**Appendix M**  
**Responses to Comments on the Draft EIR**

**Table 1**  
**List of Comment Letters on the South Bay Bus Rapid Transit Draft EIR**

12-1

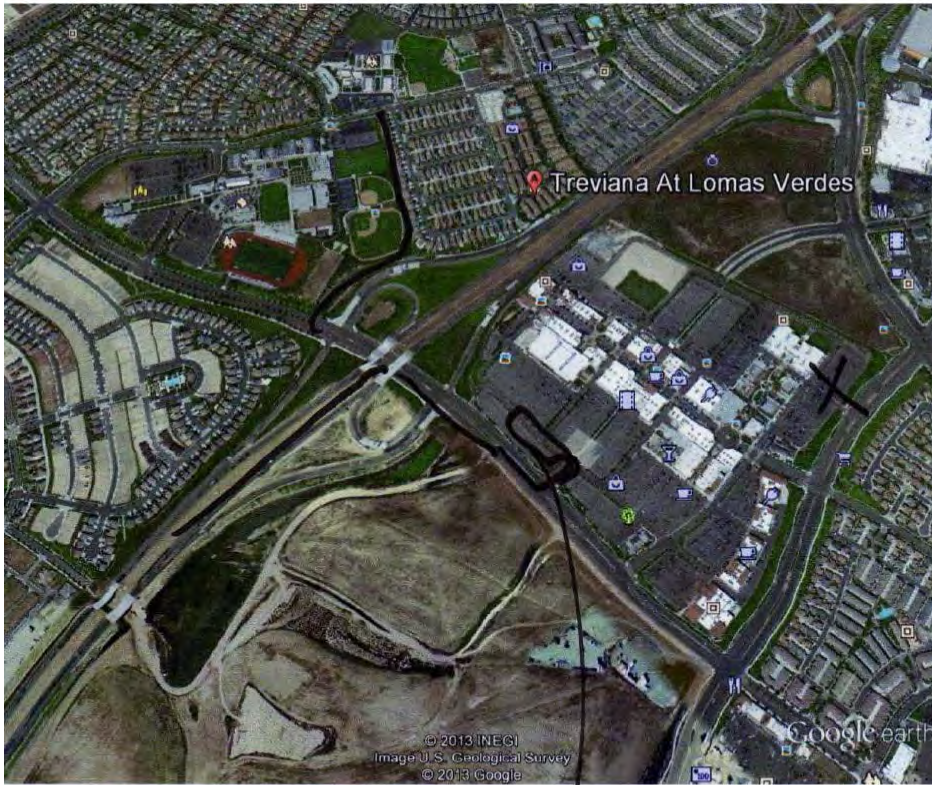
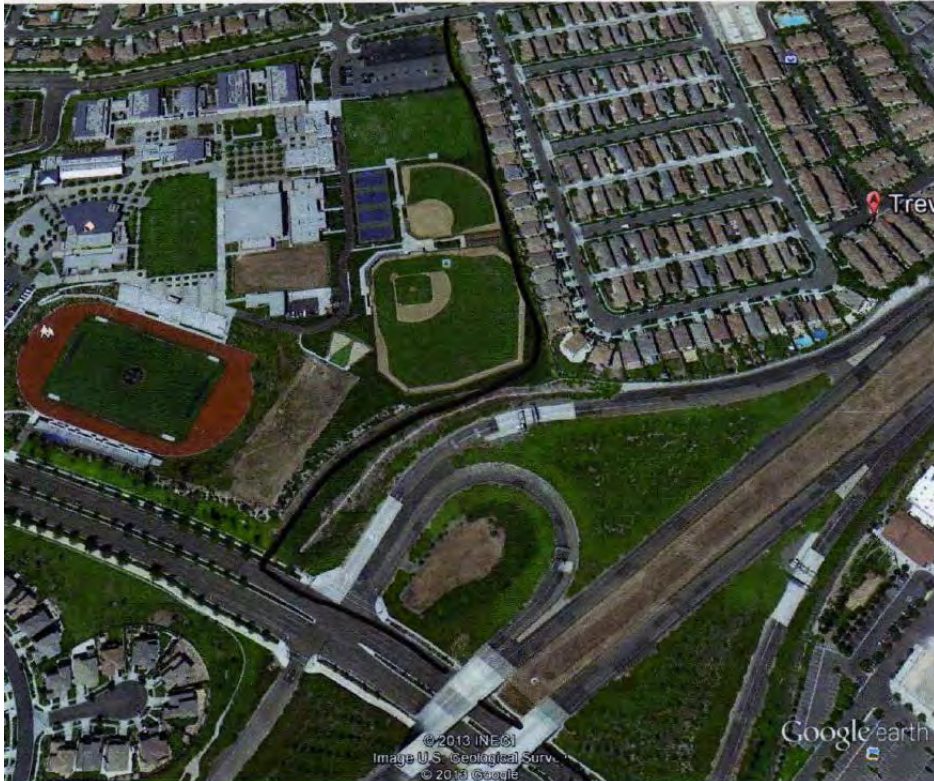
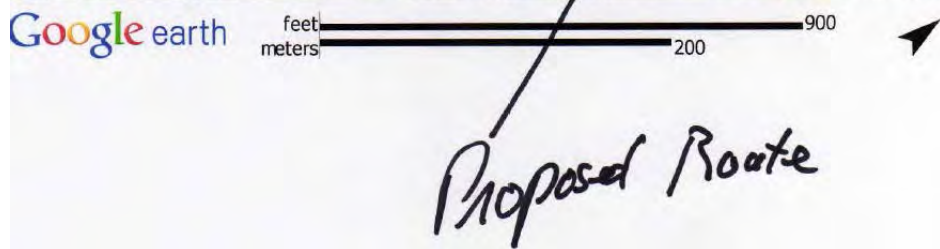
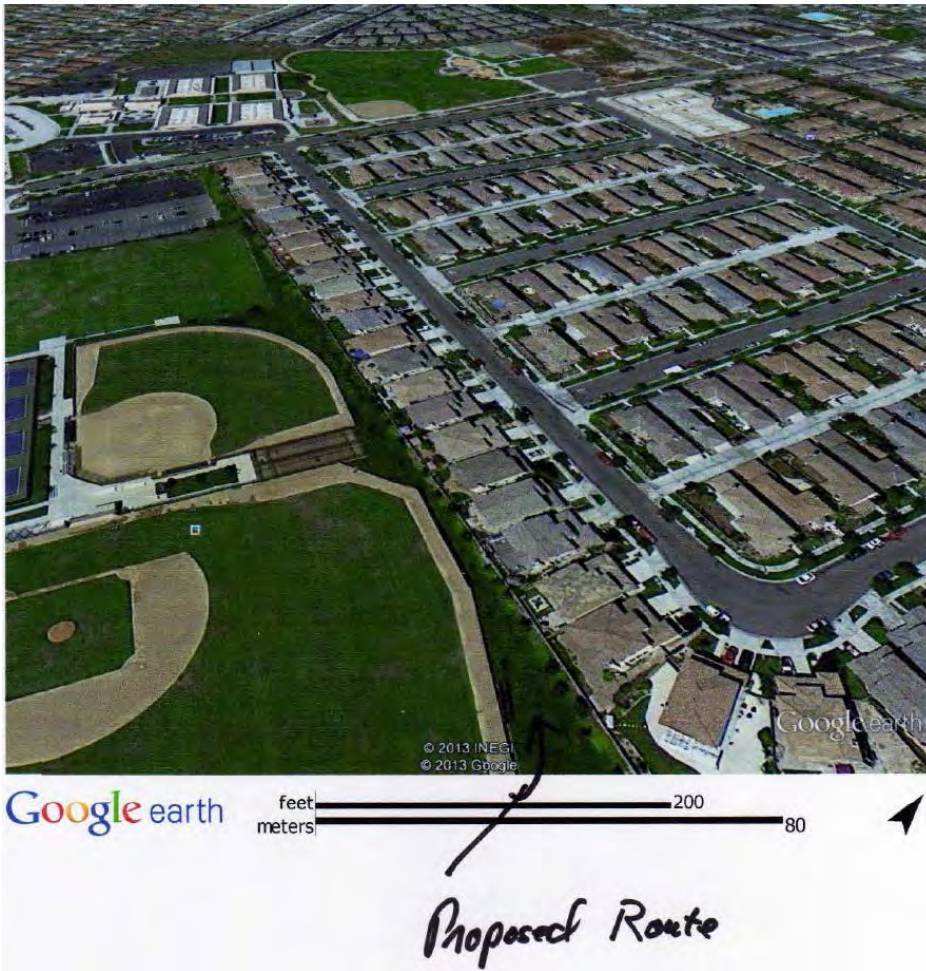
I have looked at other cities and they have been flexible with regards to neighborhoods. I hope all of you are as well. Please e-mail with any questions or comments regarding this idea.

*New  
Proposed  
Bus Stop*
